COMMITTEE OF THE WHOLE (PUBLIC MEETING) –NOVEMBER 1, 2023

COMMUNICATIONS

RE: Committee of the Whole (Public Meeting)
Weston and 7 Secondary Plan
City File No. 26.2
SmartCentres Comments

Figure 2 – Northeast Quadrant

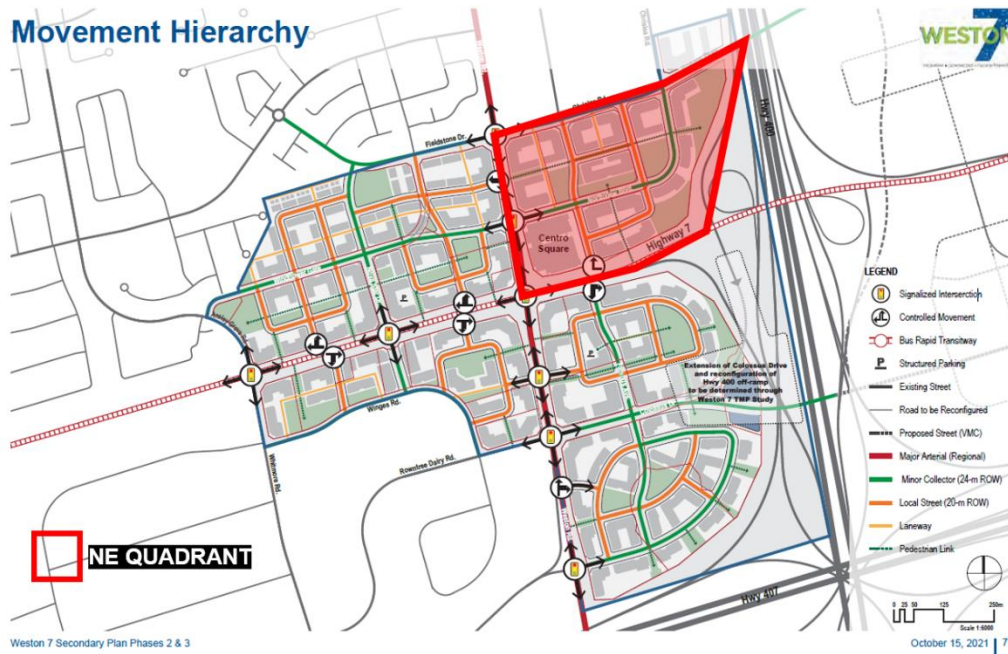
The project team’s plan (see **Figure 2**) has deleted two of the private streets SmartCentres designed and planned for by way of Official Plan Amendment Application no. OP.19.012 (i.e., the east-west link to Northview known as “Private Street 1” and the north-south link to Northview known as “Private Street 2”).

From a high level, the proposed street network layout results in remnant / irregular parcels of land, which do not contemplate nor appreciate the significant ~8m grade change along the recently re-constructed Highway 7, and the similar grade change along the Highway 400 off-ramp (see **Figure 3**). It is clear from the proposed street network (and by common-sense) that this is not an optimal location for an open space, and the project team should better coordinate with both SmartCentres and the MTO on this. Further, from a transportation perspective, the proposed street network results in very irregular / inefficient underground parking layouts, creating a sub-optimal condition from both an architectural and transportation perspective.

Figure 4 – Northwest Quadrant

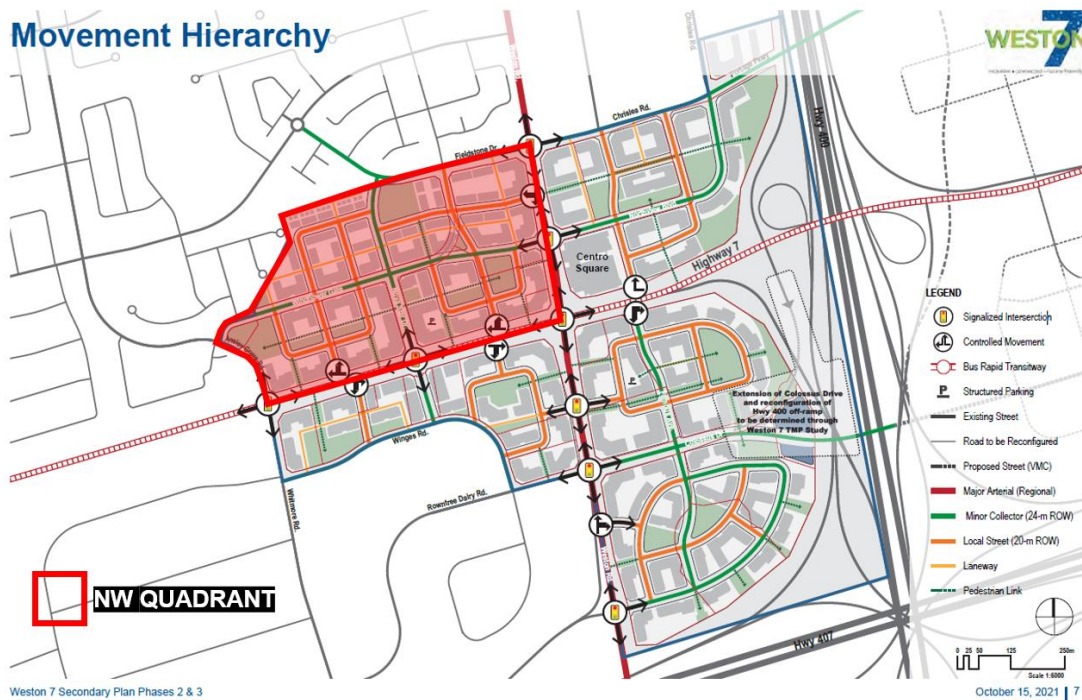
The road network and the resulting development framework has little regard for existing property boundaries and SmartCentres would need to review and ensure there are proper cost sharing mechanisms, so the burden of providing this infrastructure should not be entirely place on SmartCentres.

Figure 2 – Northeast Quadrant

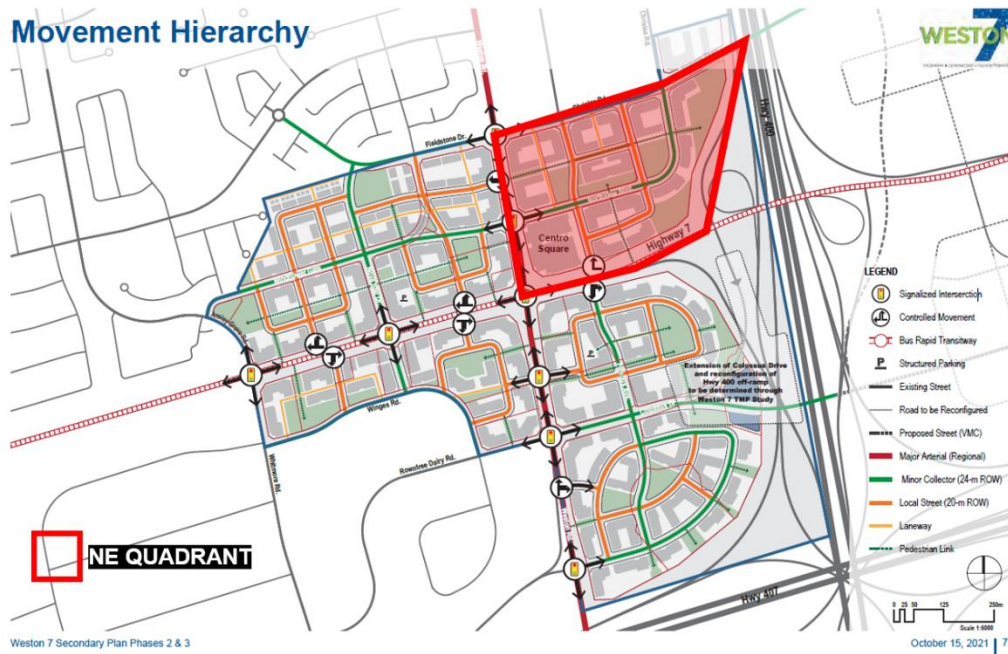
The project team’s plan (see **Figure 2**) has deleted two of the private streets SmartCentres designed and planned for by way of Official Plan Amendment Application no. OP.19.012 (i.e., the east-west link to Northview known as “Private Street 1” and the north-south link to Northview known as “Private Street 2”).

From a high level, the proposed street network layout results in remnant / irregular parcels of land, which do not contemplate nor appreciate the significant ~8m grade change along the recently re-constructed Highway 7, and the similar grade change along the Highway 400 off-ramp (see **Figure 3**). It is clear from the proposed street network (and by common-sense) that this is not an optimal location for an open space, and the project team should better coordinate with both SmartCentres and the MTO on this. Further, from a transportation perspective, the proposed street network results in very irregular / inefficient underground parking layouts, creating a sub-optimal condition from both an architectural and transportation perspective.

Figure 4 – Northwest Quadrant

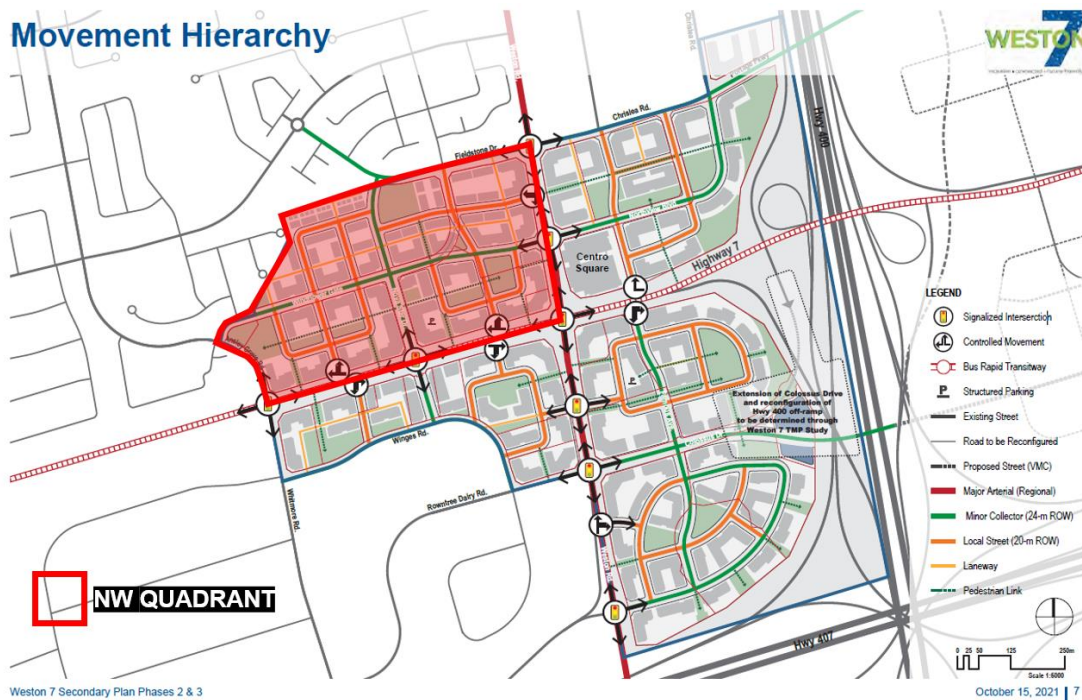
The road network and the resulting development framework has little regard for existing property boundaries and SmartCentres would need to review and ensure there are proper cost sharing mechanisms, so the burden of providing this infrastructure should not be entirely place on SmartCentres.

Figure 3 – Looking East Toward Highway 400 from the Site

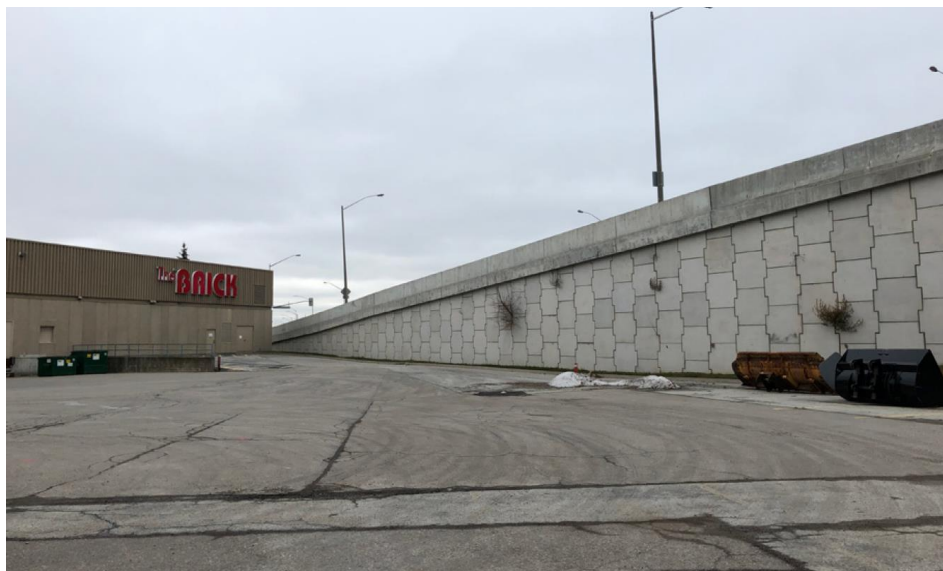
Specifically, when looking at the proposed open spaces proposed on the Calloway REIT (400 and 7) Inc. lands located at Highway’s 7 and 400, we do not feel that placing open spaces along the Highway 400 ramp system is appropriate. As currently proposed, these open spaces will be significantly negatively impacted by the existing ~8 metre grade difference from Highway 7 to our site (See **Figure 2** and **Figure 3**). In particular, the proposed open space at north-east of our site is too large and disconnected from our proposed development. The emphasis placed on highway frontage is not pedestrian friendly and will create a “back of the building” built environment. Further, the proposed parkland at south east corner of the site will have the same emphasis on highway frontage and is not a good location for parkland, given the significant grading differences – as proposed by the city, this park would essentially be a drainage basin. Through our Master Plan submission to the City, we have reviewed these conditions in detail and determined that minimizing the open spaces along the Highway 400 ramp system and internalizing the open spaces between buildings was more appropriate and resulted in better microclimate conditions. We strongly urge that this placement be further reviewed and reflective of our Master Plan and would like to work with Staff accordingly.

Figure 3 – Site Plan Overlay on Weston 7 Secondary Plan Schedule 4 – Transportation System

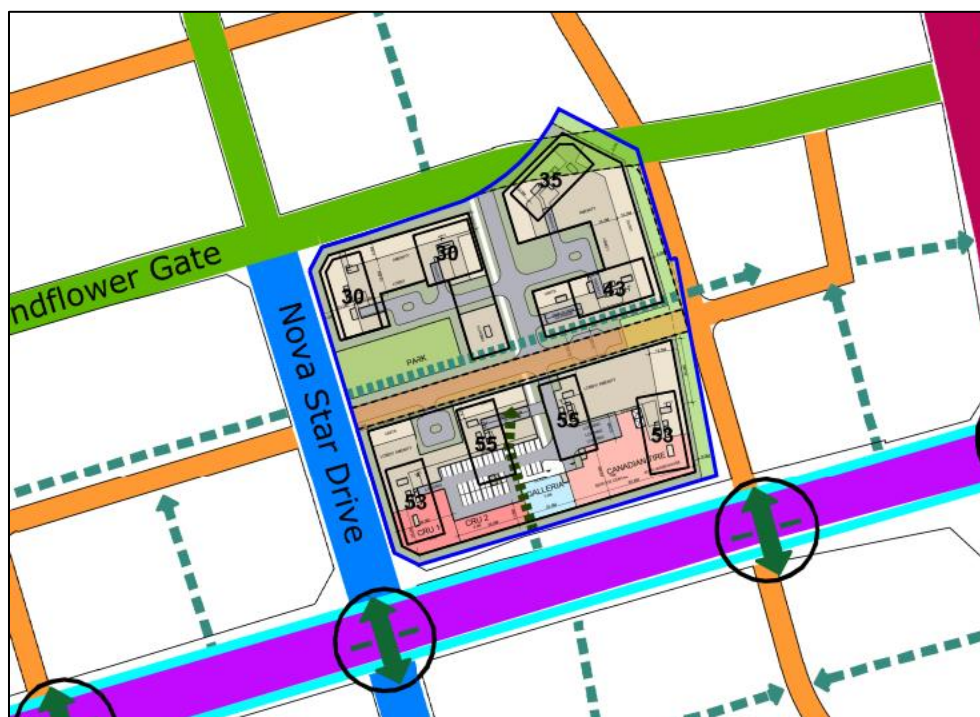
- The draft Transportation System schedule has been updated to address the inconsistencies between the TMP and the first draft of the Weston SP. However, the draft schedules still propose to extend a portion of Windflower Gate east through a portion of the subject property. We would like to reiterate our comment in the previously submitted comment letter and request consideration that Windflower Gate be realigned in a way that avoids or minimizes impact to the existing north-east corner of the subject property.

- Further to the general comment provided above regarding the integration of the Road Network and Active Transportation Network, we believe that the proposed north-south Active Transportation Link bisecting the subject property from Highway 7 should be relocated on the map or subject to policies that provide flexibility in the location of the Active Transportation Link without requiring an amendment to the SP. Furthermore, as per Section 7.1.3, where a development block exceeds 180 metres on any public road, it shall be provided with a mid-block Active Transportation Link. It is noted that the frontage of the subject property is approximately 160 metres, which is below the 180 metres requirement. We request that the SP provide a policy that allows for flexibility in the location of the Active Transportation Link on the subject property.

Figure 2 – Site Plan Overlay on Weston 7 Secondary Plan Schedule 4 – Transportation System

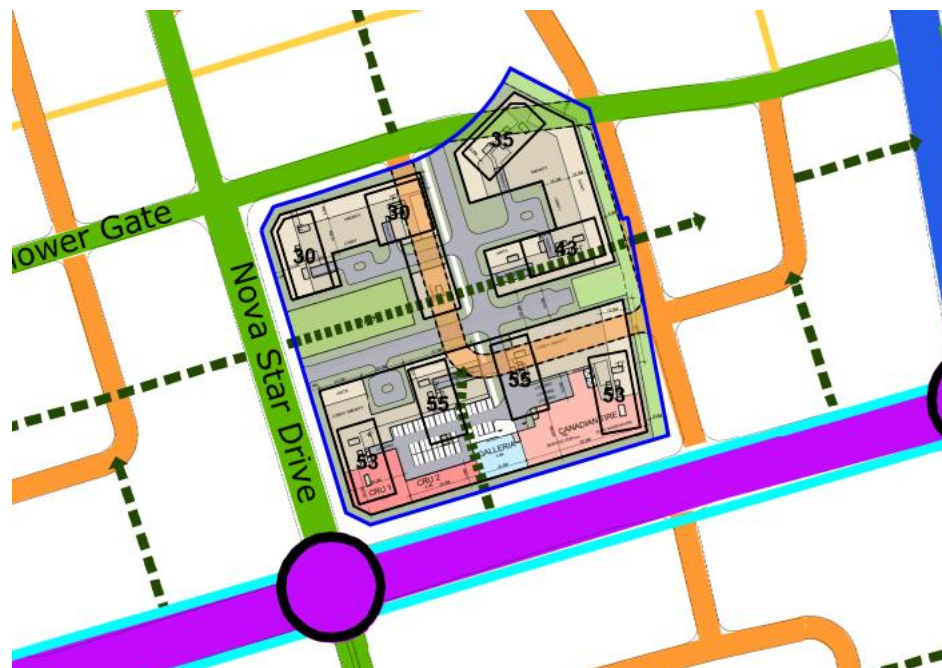
According to the proposed draft schedules, the east-west portion of Windflower Gate is proposed to be extended east through a portion of the subject property and the portion of Windflower Gate is proposed to be extended south along the eastern boundary of the subject property. The proposed east-west Windflower Gate extension appears to impact the north-east corner of the subject property, ultimately impacting the net developable area of the site (Figure 2).

Based on proposed draft Schedule 4 (Transportation System), we are of the opinion that Windflower Gate, identified as a Collector Road, could still extend east to Weston Road, but should be realigned in a way that avoids or minimizes impact to the existing north-east corner of the subject property. While we are supportive that the Weston 7 SP includes proposed policy that permits minor adjustments to the approximate location of roads, provided that the general intent of the Plan is preserved, we request that the proposed Collector Road on Schedule 4 (Transportation System) be modified to address our above-noted concern regarding the current lot configuration.

Figure 2: Schedule 2, Building Height

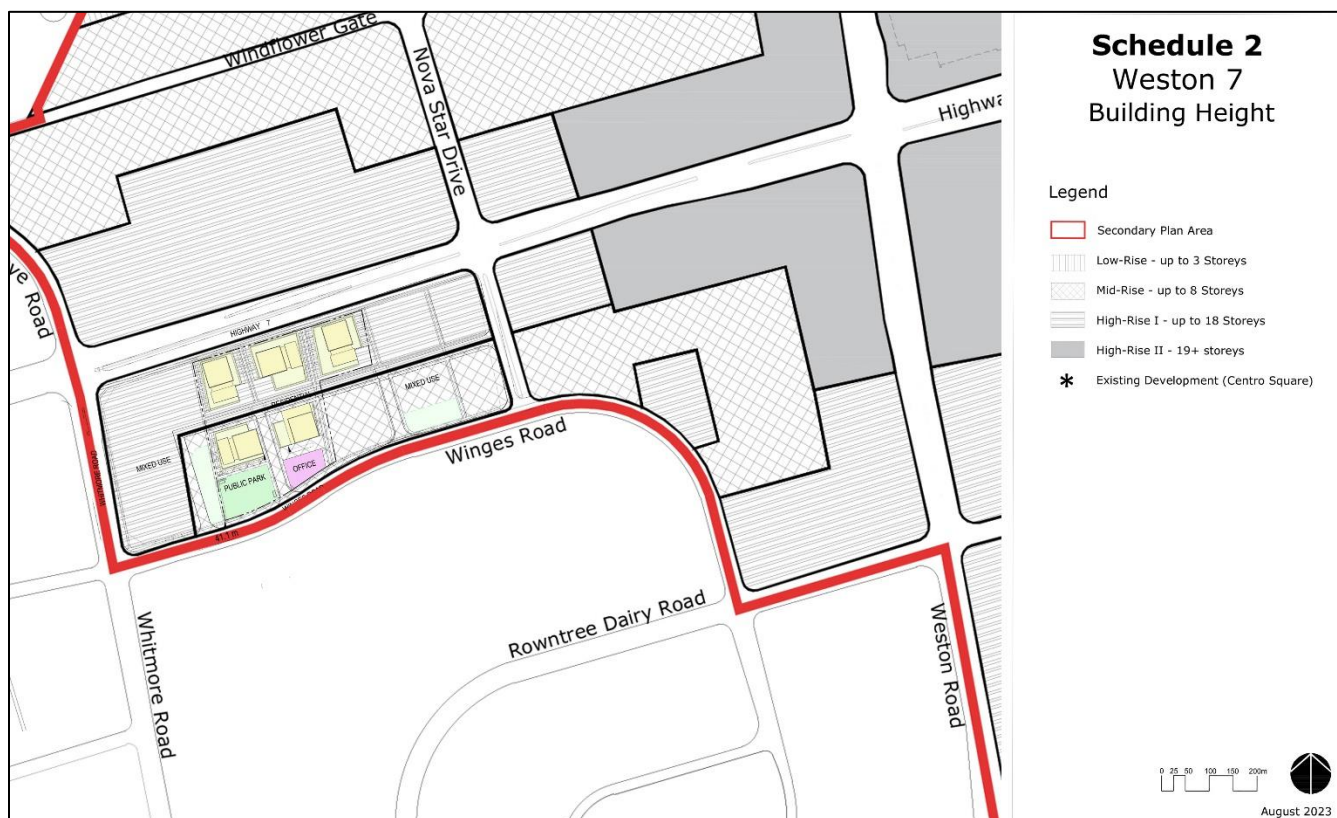
The proposed development is proposed to be have differentiated designations: *Mid-Rise, up to 8 storeys* (on the south side), and *High-Rise I up to 18 storeys* (on the north side) per Schedule 2, Building Heights, illustrated on Figure 2. As such, the (3) buildings along Highway 7 are proposed to be *High-Rise I*, while the (3) buildings to the rear are proposed to be *Mid-Rise*. The following comments are provided as it relates to building heights, as well as the policies contained in Section 4.2 of the W7SP.
